**CALIFORNIA COASTAL COMMISSION**

# Th10c

**Application Number:** 5-12-320

**Project Description:** Construction of a eleven-foot wide pedestrian path (using a resin-based paving material) along 3.1 miles of the shoreline, construction of a new pedestrian/bicycle ramp on the east side of the Belmont Veterans Memorial Pier, and relocation of the beach bicycle path inland to a new alignment closer to the Belmont Pool and the La Verne Avenue public beach parking lot.

Figure 2. 8:18AM, 7.70' High Tide @ 12<sup>th</sup> Place. Beach width = 60'.

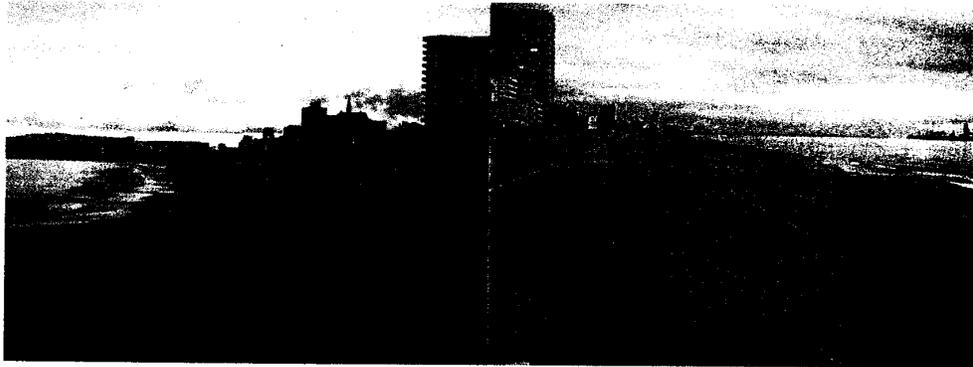
During the last king tide of December 13, 2012, the high tide line was observed to be quite close to the existing bicycle/pedestrian path. As shown in Figure 2, during the high tide, the distance between the high tide line and the path was approximately 60 feet at 12<sup>th</sup> Place. If the proposed pedestrian path extends 20 feet seaward of the existing path, only 40 feet of beach would remain.

Figure 3. Observed Water Levels for December 13, 2012

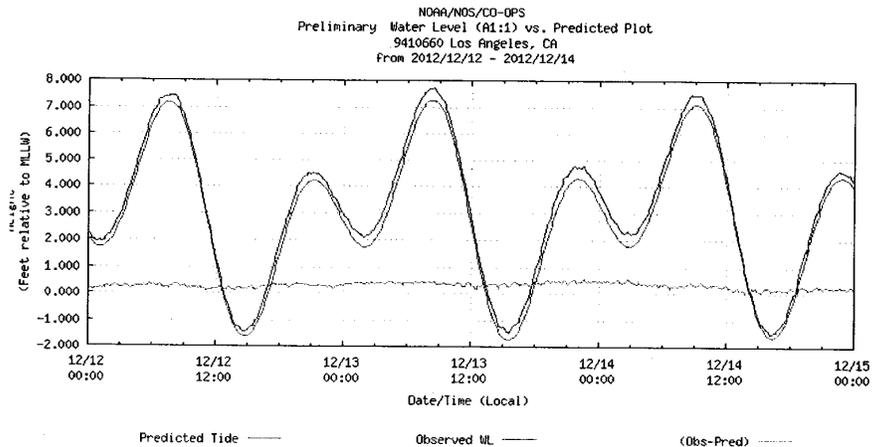
Observed tidal record for December 13<sup>th</sup> is shown in Figure 3. While the tide shown in Figure 3 was quite high, it was not the highest on record and with sea level rise, even higher tides are expected.
